**LEGAL ADVERTISEMENT
HISTORIC PRESERVATION BOARD
CITY OF PORTLAND**

**PUBLIC HEARING
392 SPRING STREET**

WORKSHOP
383 COMMERCIAL STREET

WORKSHOP
742 CONGRESS STREET

ATTACHMENT 2

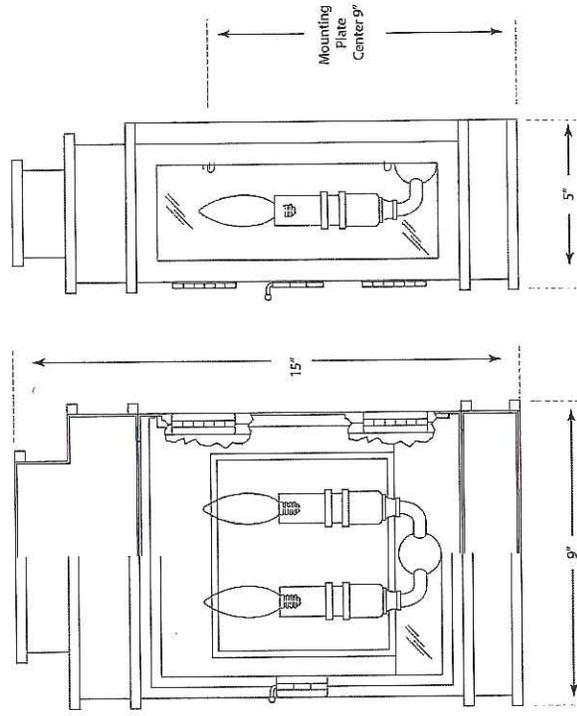
- Proposed new lighting on the face of the garage is shown; Ms. Winter provided a possible fixture type, which is a tradition bronze lantern (see Attachment 2.) On the Mudroom, recessed downlights in the overhangs over the landings will be minimally visible.
- Copper half-round gutters matching those on the house are proposed for the front and rear of the mudroom, but the rear additions, where the proposed siding is zinc shingles, is shown with zinc gutters.
- Paint for siding and trim is still proposed in the same shade of grey as the shutters.

- Staff suggests the traditional lanterns and carriage house style doors proposed for the front of the garage will emphasize the traditional design, in contrast with the clean, contemporary mudroom. Perhaps quieter, less traditional lighting that is more neutral rather than period would tie the design together slightly more. Also, staff wonders whether two fixtures would suffice.

SPRING STREET ELEVATION
SECTION TOWARDS HOUSE SIDE ELEVATION
SECTION THRU MUDROOM

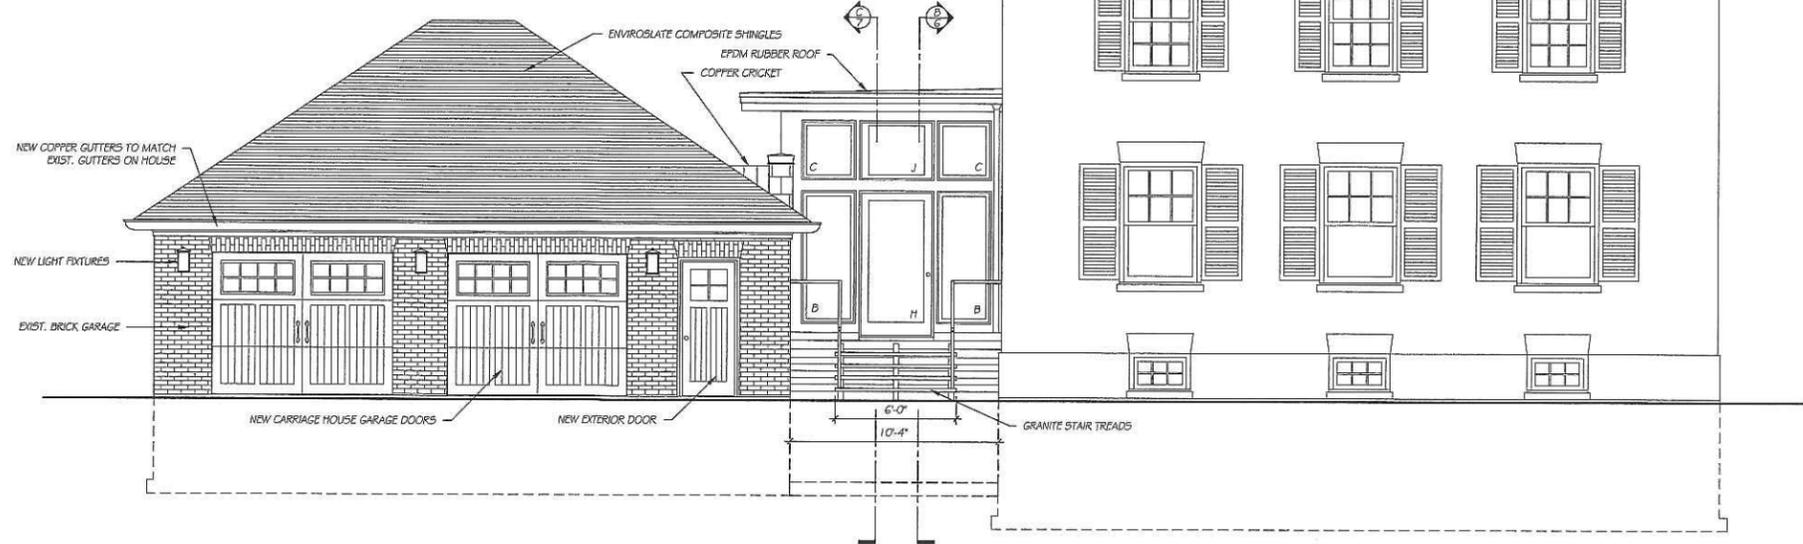
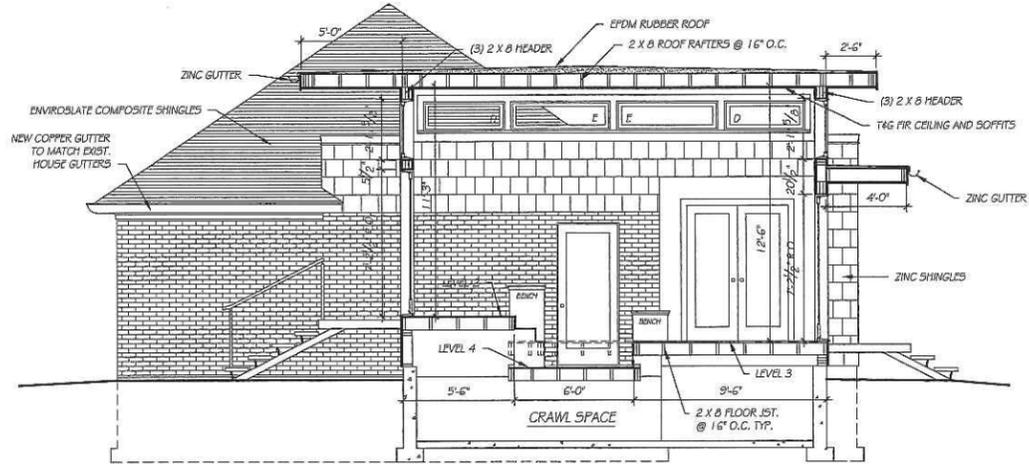
- At this time it is unclear how the somewhat visible face of the mudroom foundation (facing Spring Street) will be treated.

- Before the June 6 meeting staff will attempt to clarify with the designer what the appearance of the front mudroom foundation will be, behind and to either side of the stairs.

REAR AND GARAGE SIDE ELEVATIONS
 SECTION THRU MUDROOM TOWARDS GARAGE
 MASTER BATH AND BREAKFAST ROOM SECTION

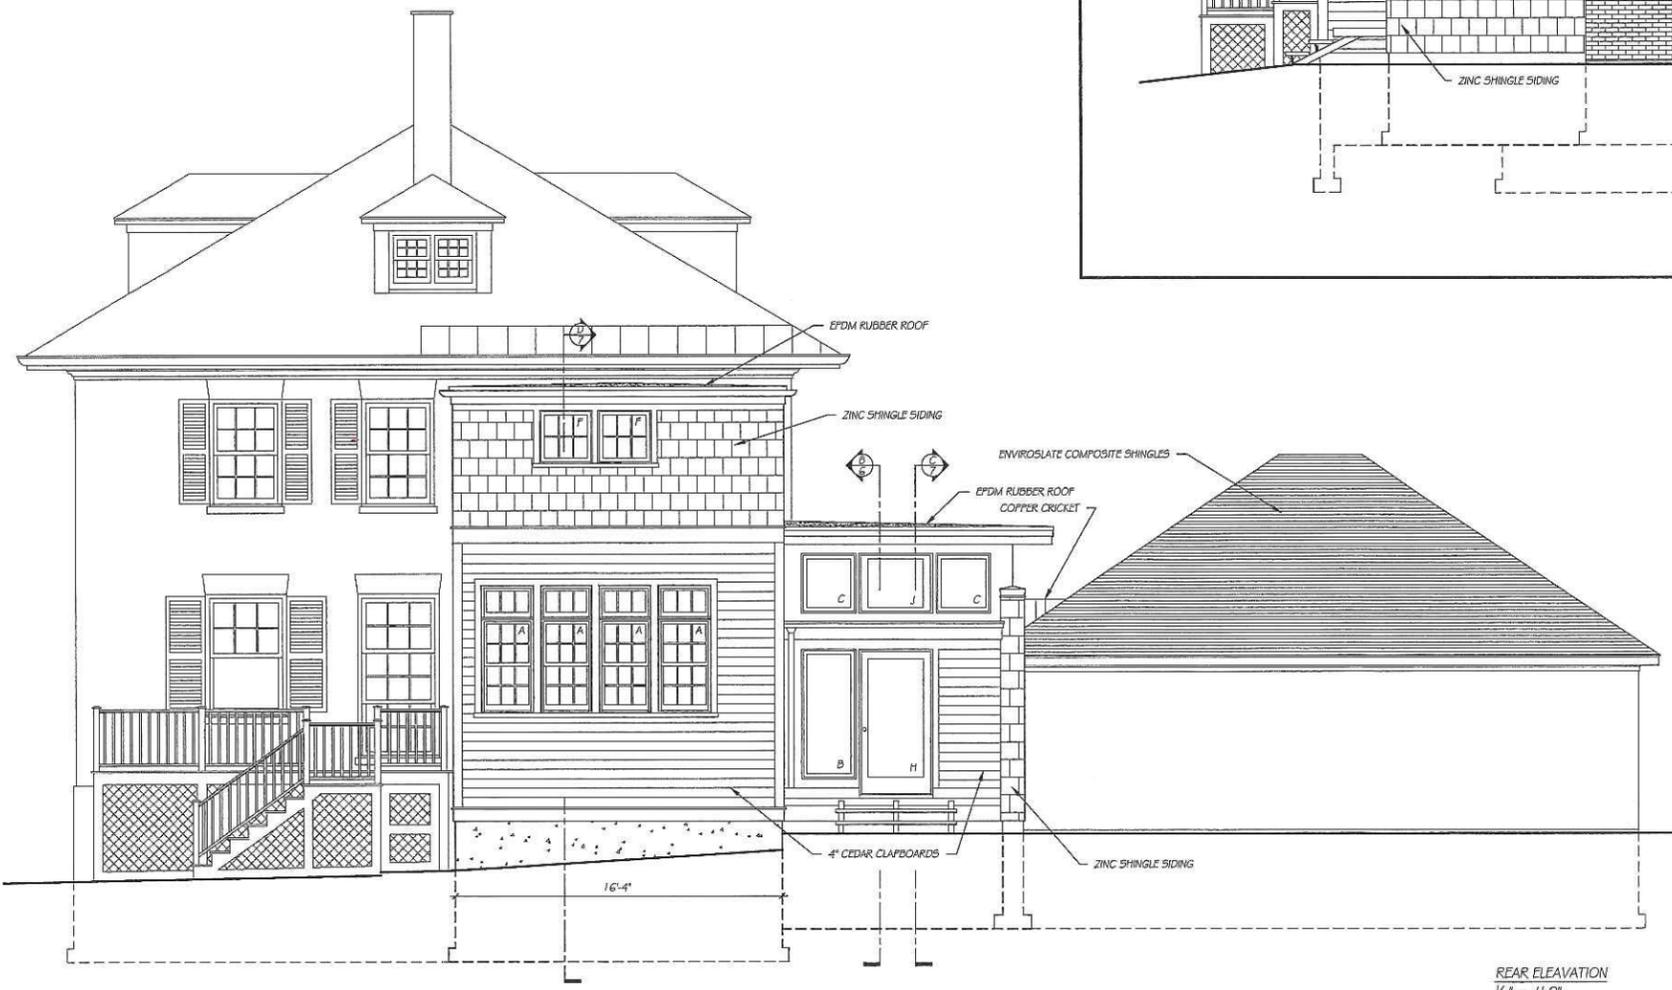
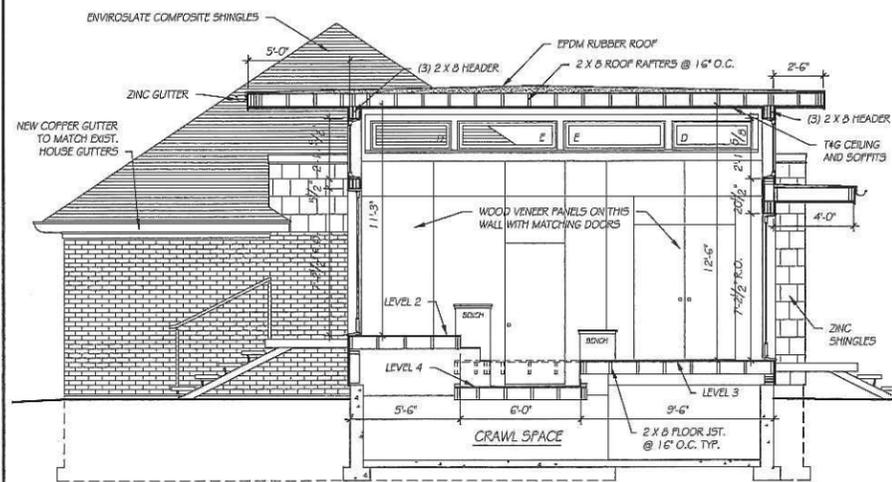
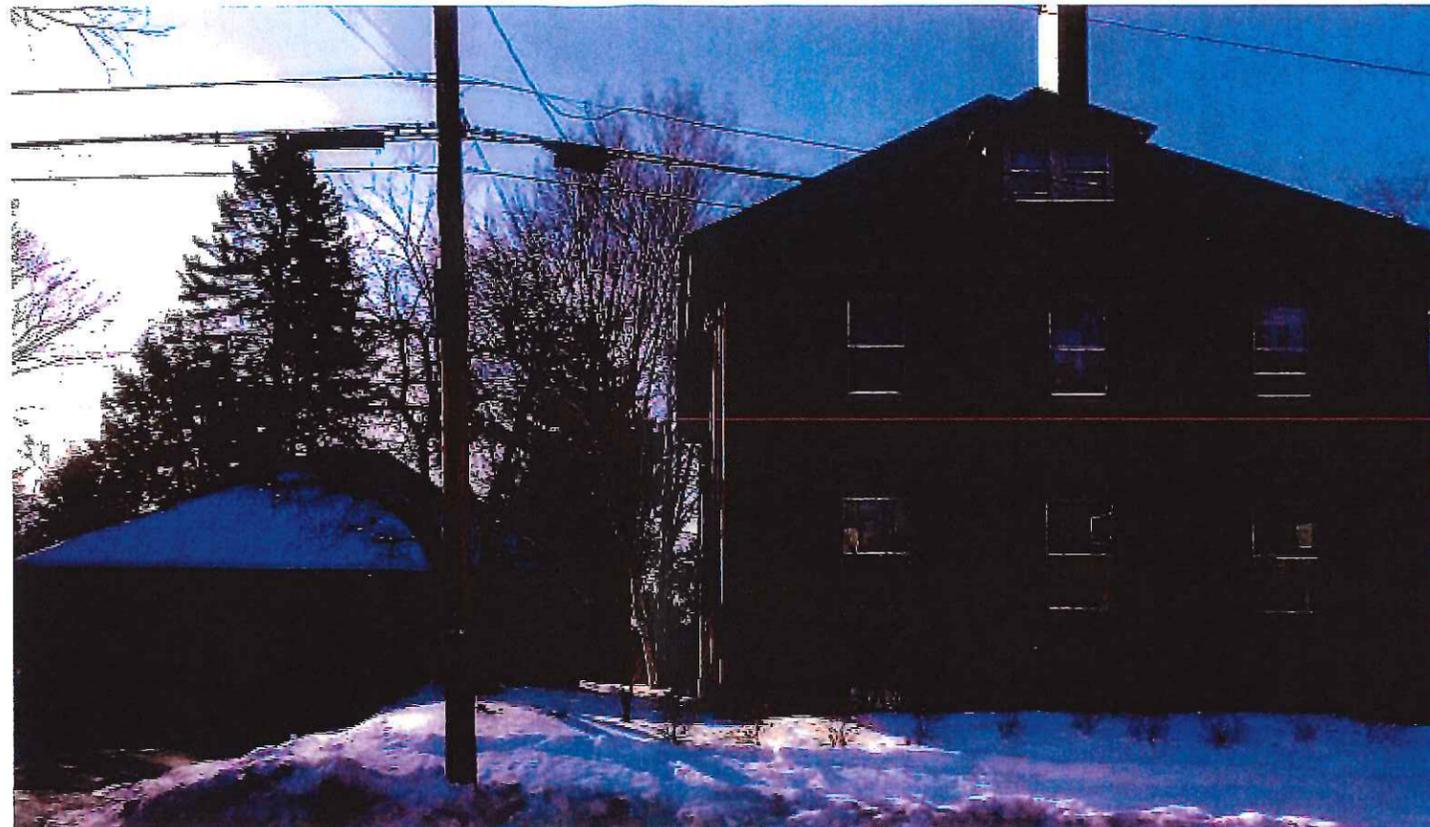
- Ms. Winter's drawings (Attachment 3) show the upper walls of the rear addition sided with zinc coated shingles, instead of enviroslate artificial slate shingles. According to the designer, the zinc shingles can be sized according to need; the exposure shown on the submitted elevations is about 9" and they are 10" wide.

- The Board will no doubt discuss whether the switch to zinc shingles on the upper rear addition and the garage wall extensions that serve as the east wall of the mudroom will be a successful substitution. At the workshop, a Board member suggested that the material might meet the goals of tying the various components together, blending with the rest of the addition, and distinguishing the siding from the roof treatment.

- A copper gutter similar to those on the house is proposed for the front (and rear) of the new mudroom, while zinc gutters are shown on the rear addition – consistent with the upper floor siding. The rear addition is only visible at a distance, so perhaps it is not a critical choice, but the zinc might be the better choice as it would blend, not contrast with the recessive coloration of the addition. On the other hand, it would differ from the other gutters.
